PROJECT: Truman Waterfront Park Project

**Location:** Truman Waterfront Park, Key West  
**Scope:** FCD007 Retention Pond E

**FIELD CHANGE DIRECTIVE  
No. 07**

PROJECT: **Truman Waterfront Park Phase 1A**

CP-05

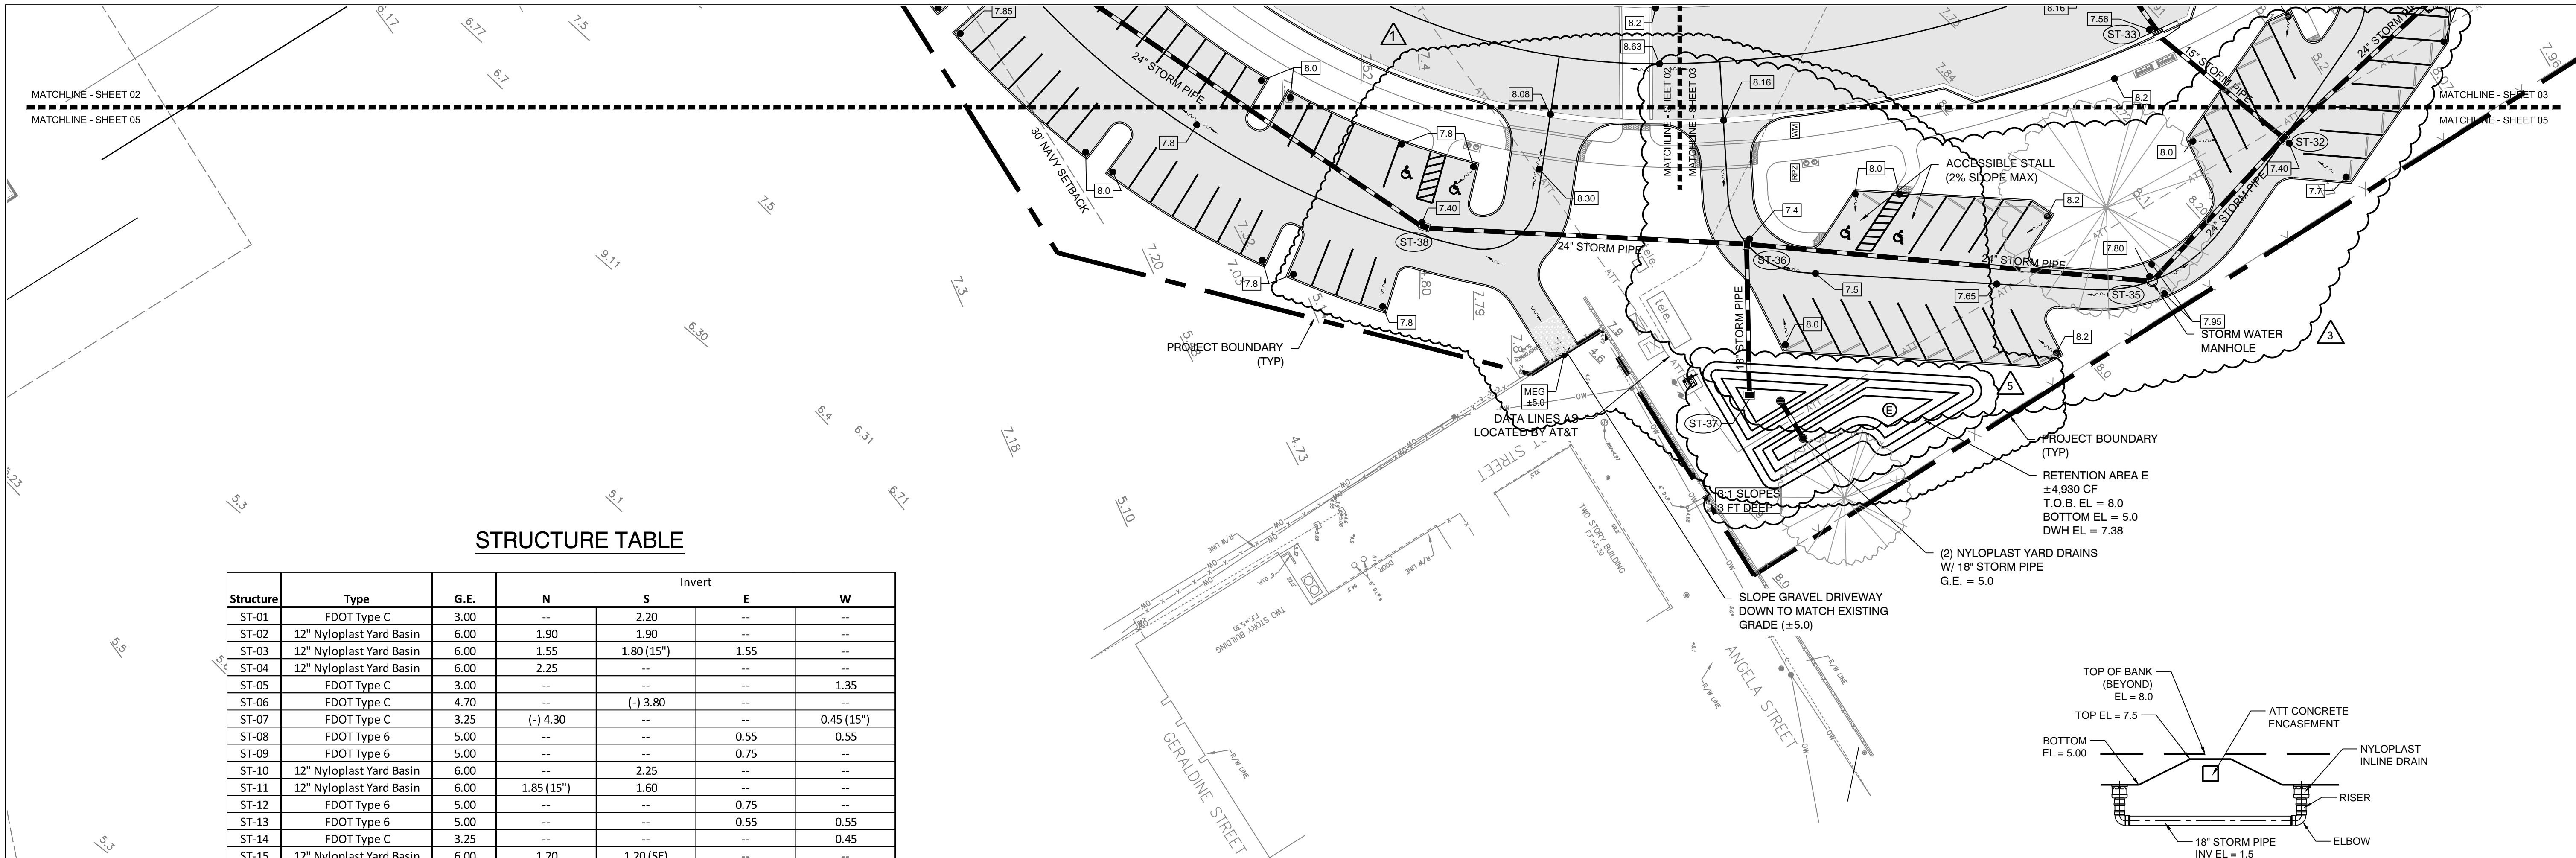
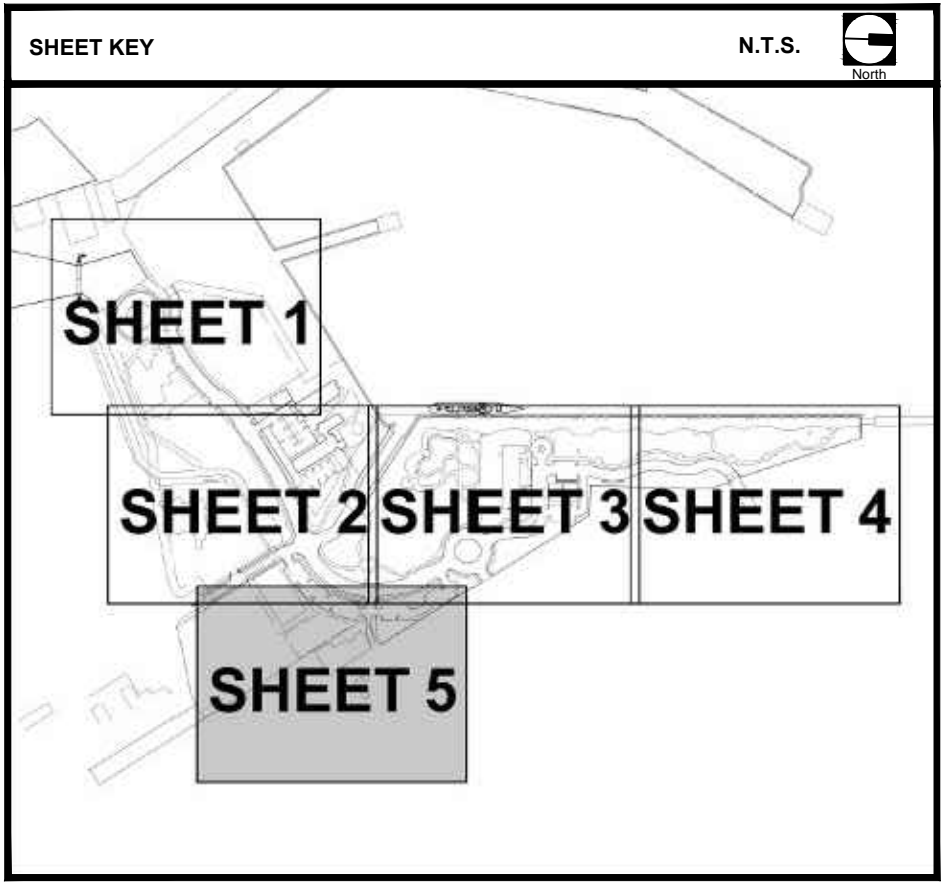
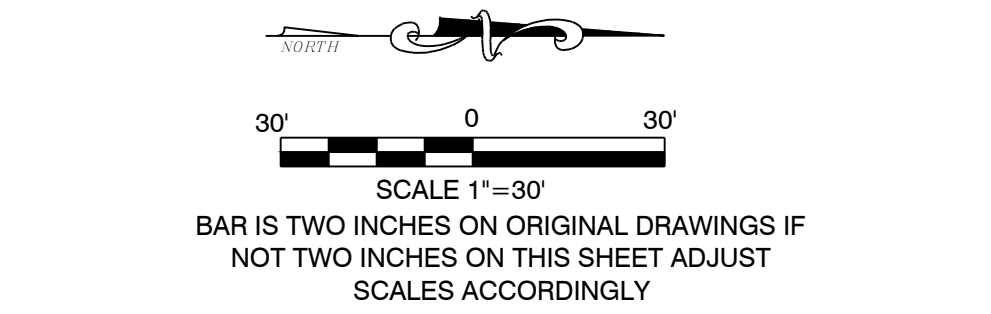
Description: **Construct Retention Area E as indicated on the attached drawing CP-05. Provide cost to furnish and install Nyloplast Yard Drains to facilitate water movement beneath the conduit (to remain).**

- 09-29-15 ADDENDA No. 2
- 03-18-16 ROAD REALIGNMENT
- 03-31-16 SEAGRAPE PARKING
- 04-28-16 IRRIGATION MODIFICATIONS
- 06-01-16 RETENTION POND E MODIFICATION
